BEFORE THE SELWYN DISTRICT COUNCIL

UNDER	the Resource Management Act 1991
IN THE MATTER OF	Lodgement of Private Plan Change 69 with Selwyn District Council
BETWEEN	Rolleston Industrial Developments Limited
AND	Selwyn District Council

**SUMMARY STATEMENT OF MATHEW (MAT) ROSS COLLINS
ON BEHALF OF SELWYN DISTRICT COUNCIL**

Transport

Figure 2: Connections to adjacent urban areas

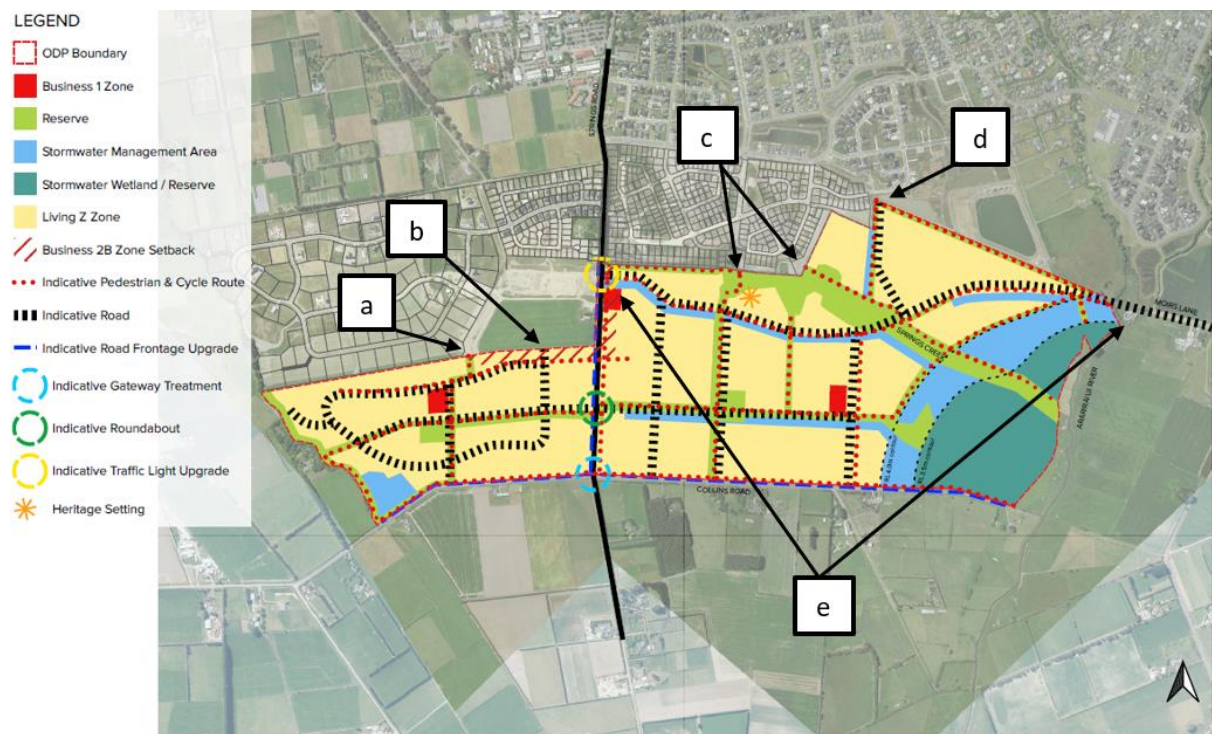
8.2 I have summarised the transport links to adjoining areas, identified in the ODP and in Figure 2 below, and have provided comments on each

(a) A green link connection to Verdecos Park. I support this connection, however I am unsure whether the local purpose reserve in Verdecos Park (Lot 406 of Subdivision RC185367) includes walking and cycling facilities as far as the boundary with PPC69

(b) A future proofed roading connection to the Business 2B zone of Verdecos Park. I support this connection and consider that it is likely to be formed when the Business 2B zone is developed

(c) A pedestrian cycle connection to Te Whāriki via Springs Creek. I support this connection however I am unsure whether the local purpose reserves in Te Whāriki (Lot 414 and 415 of Subdivision RC205181) include walking and cycling facilities as far as the boundary with PPC69

(d) A potential road connection to Te Whāriki, however this would rely on using a utility reserve vested in Council to form the connection

(e) Springs Road and Moirs Lane connections. Key roading connections to the existing/future Lincoln urban area.

8.3 This results in two certain road connections, one possible road connection, and 3 pedestrian/cycling connections along the interface of PPC69 with the existing and future Lincoln urban area. This interface is approximately 3.5km long (from the eastern to western extent of PPC69, following the plan change boundary). I consider this presents a low level of connectivity for all transport users, and I note that this is consistent with the view of Mr Nicholson.

8.6 Should Council determine that the utility reserve can be used to form a road connection to Te Whāriki, I consider that PPC69 should be responsible for all costs associated with planning approvals and construction.
